METROPOLITAN GOVERNMENT OF NASHVILLE AND DAVIDSON COUNTY

STAFF RECOMMENDATION
1913 19th Avenue South
March 17, 2021

Application: New Construction-Addition
District: Belmont-Hillsboro Neighborhood Conservation Zoning Overlay
Council District: 18
Base Zoning: R-8
Map and Parcel Number: 104120175
Applicant: Van Pond
Project Lead: Jenny Warren, jenny.warren@nashville.gov

Figure 2. Left side elevation. Height increase begins 62' from the front of the house.

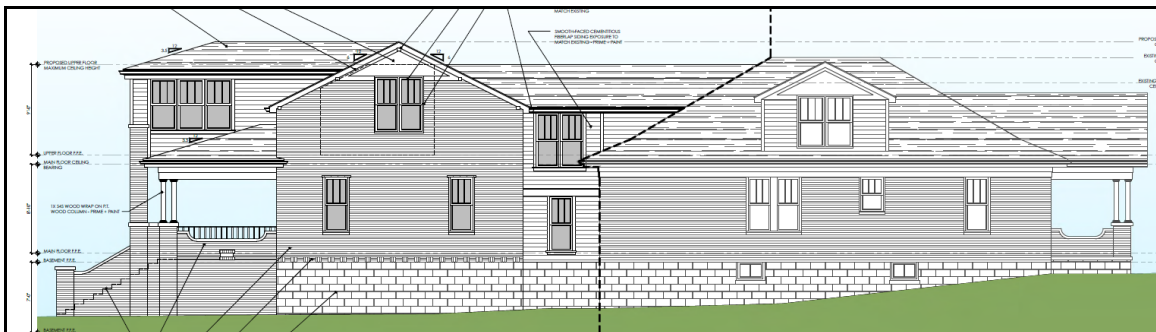
Height & Scale: The ridge of the historic house is about twenty feet (20') from the foundation height. The proposed addition ties in below the historic ridge and, about sixty-two feet (62') back from the front wall, the height rises to be about twenty-one feet, six inches (21'6"). The guidelines allow for additions that step up to four feet (4') taller if they are forty feet (40') back from the front of the house.

The house is shifted on the lot, sitting about three feet (3') from the left side property line and about twelve feet (12') from the right side. This shifted site plan meets the criteria for a rear addition that steps wider. The applicant is proposing a wider addition on the

right side. After an appropriate one foot (1') by seven foot (7') inset, the addition will step out to be approximately seven feet, six inches (7'6") wider. The wider portion will be all one story with an eave height that matches the historic house. The majority of the wider portion of the addition will be an open covered porch. There will be about two feet (2') of solid wall projecting wider than the house on the first floor only. The second floor will step in behind the face of the existing side dormer and will have eaves that are slightly lower than the historic dormer eaves.

On the left side, the addition will inset about five feet (5') for a depth of about seven feet (7') before stepping back out three feet (3') toward the property line. The main wall of the addition will be inset two feet (2') from the main wall of the historic house. The eaves will be slightly lower than the eaves of the historic dormer. (Figure 2)

Figure 4. Site plan

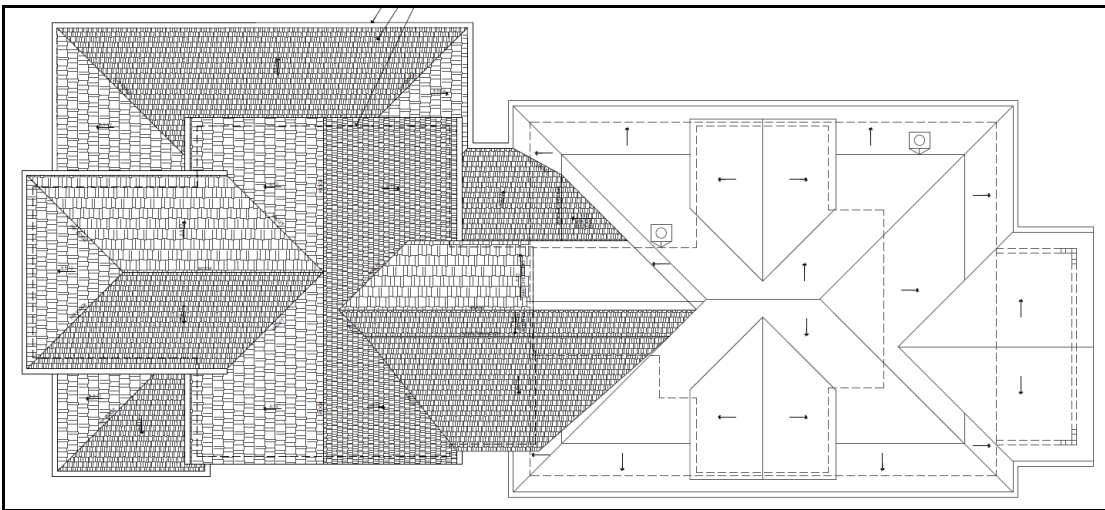
Setbacks: The addition will meet the five foot (5') side setbacks. The existing house encroaches on the left side setback, but the addition will be inset such that it will not require a setback determination. On the right side, the open side porch will extend to the side setback line.

The rear steps of the addition will reach the twenty foot (20) rear setback line. The project meets section II.B.1.c.

Figure 5. Roof plan

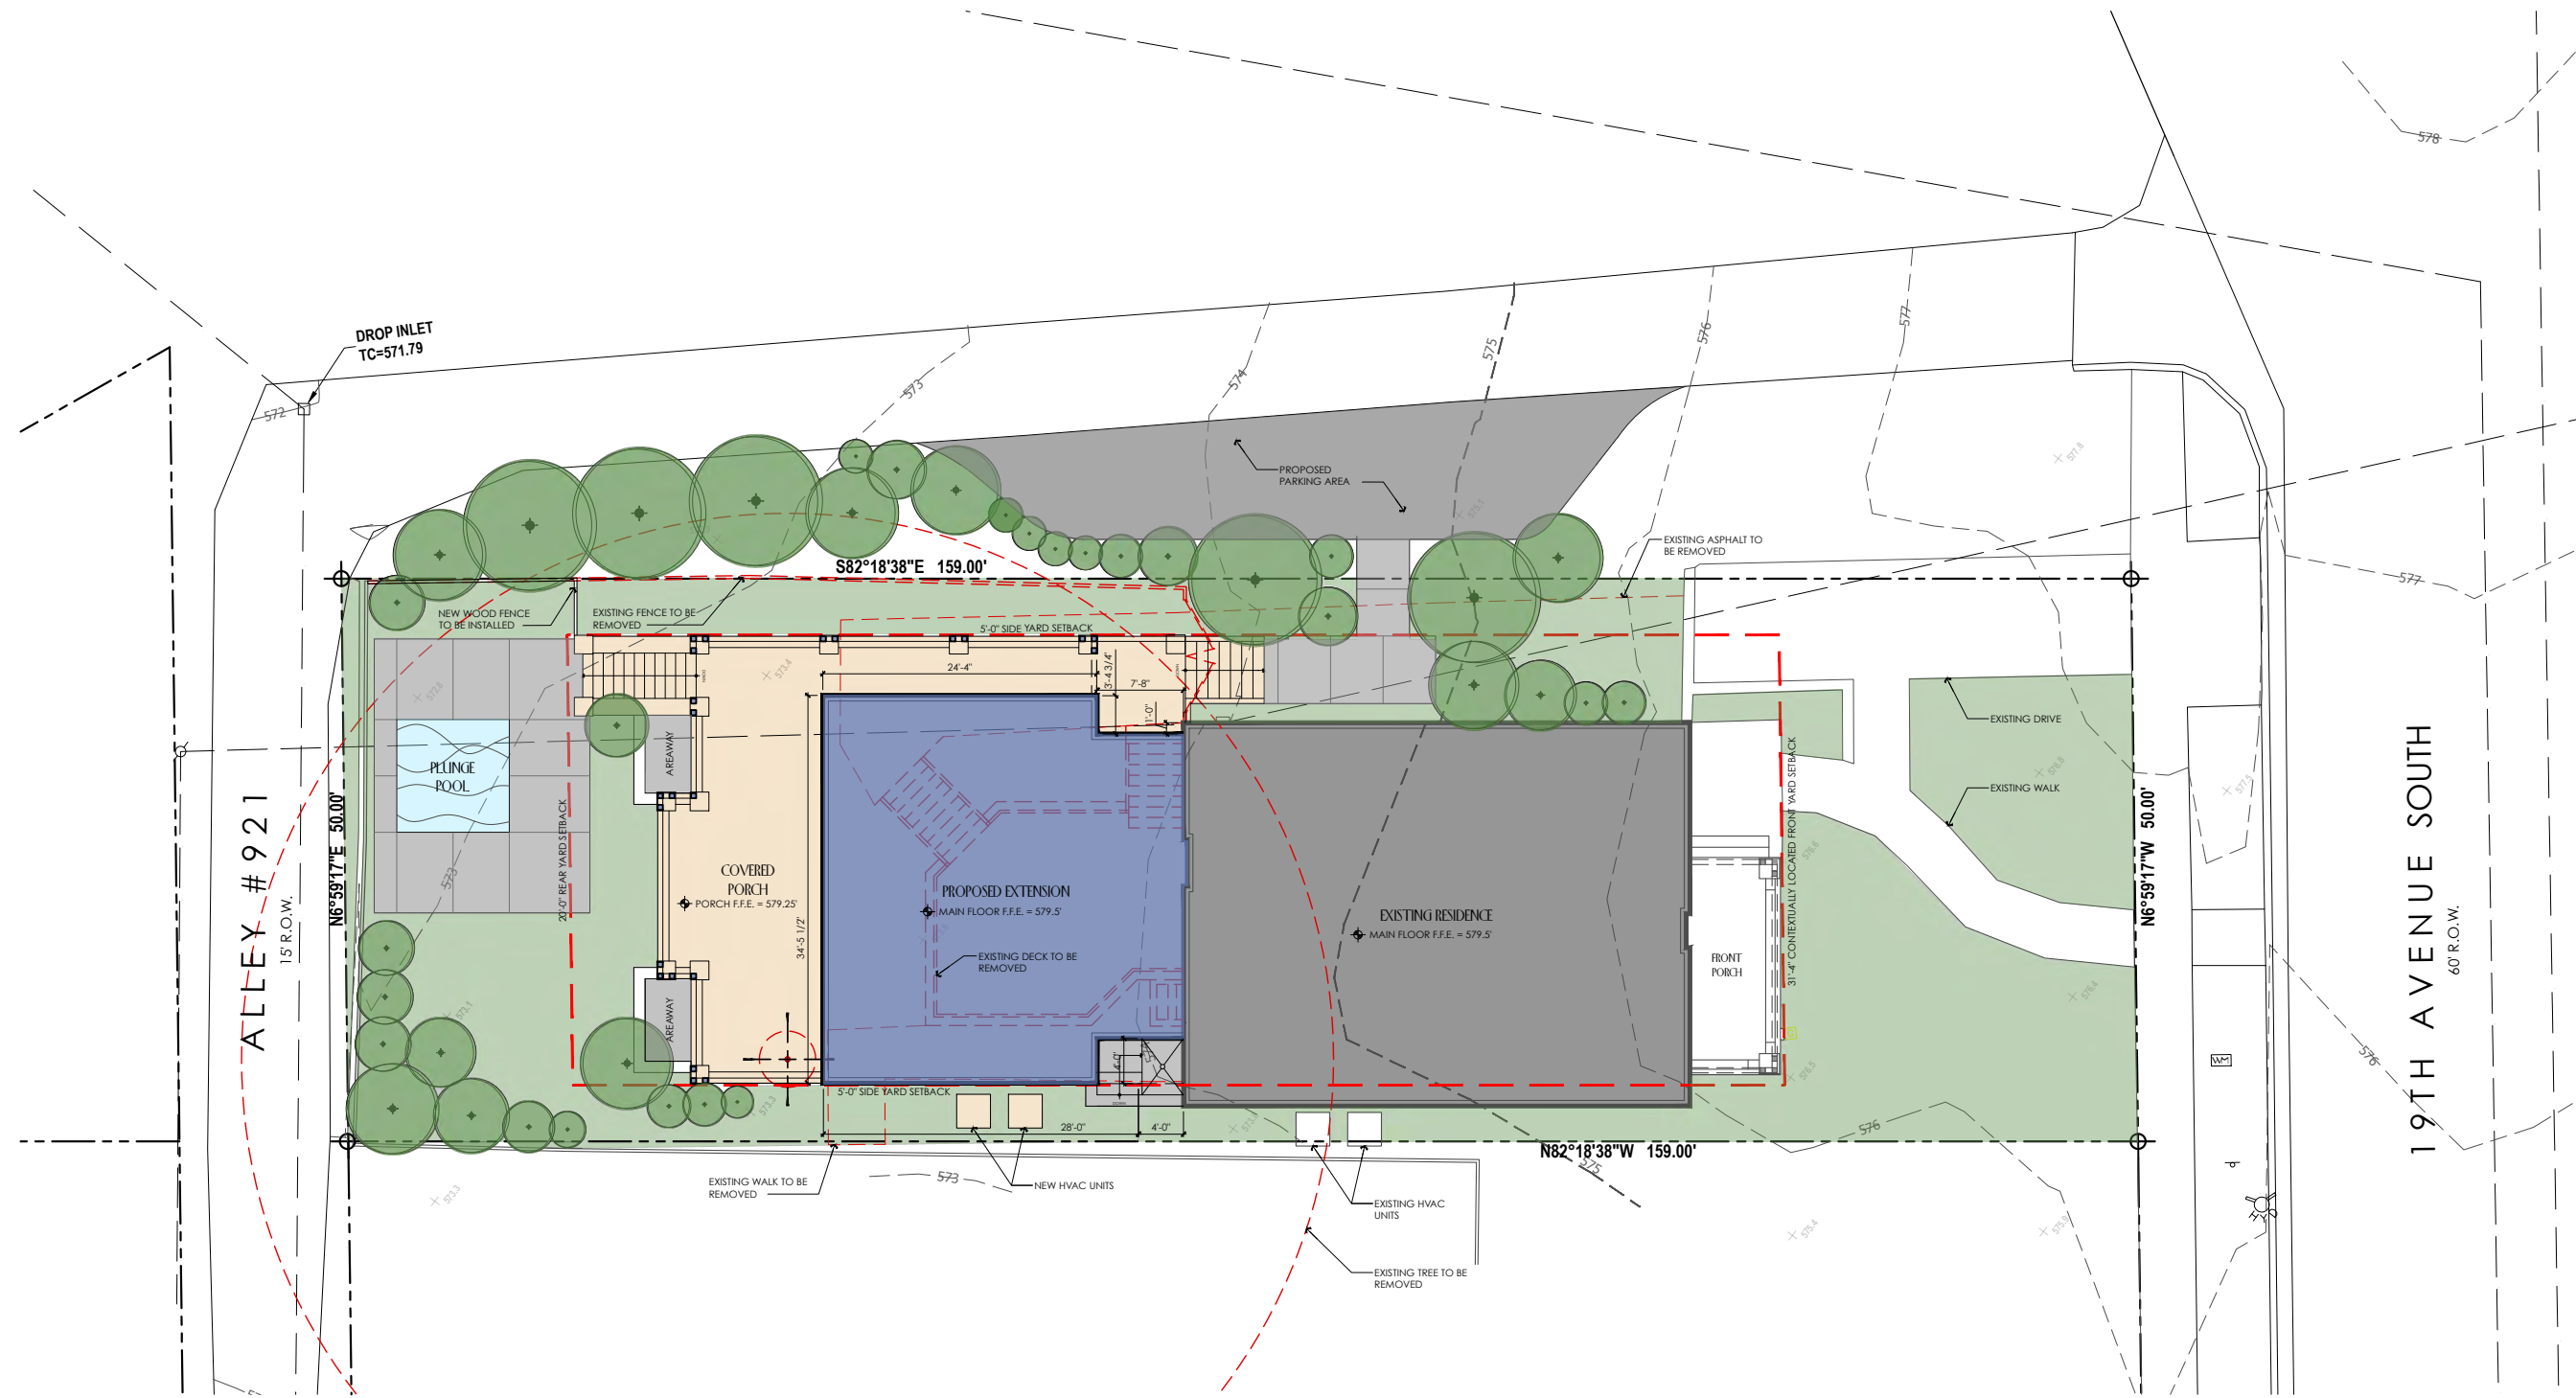
Roof form: The addition connects to an existing rear dormer. The main ridge uses a side gabled form with a 6/12 pitch. There is also a rear-facing gable form, and the one-story porch has a hipped roof: both these forms have a 3.5/12 slope which is appropriate for porches and dormers.

The project meets section II.B.1.e.
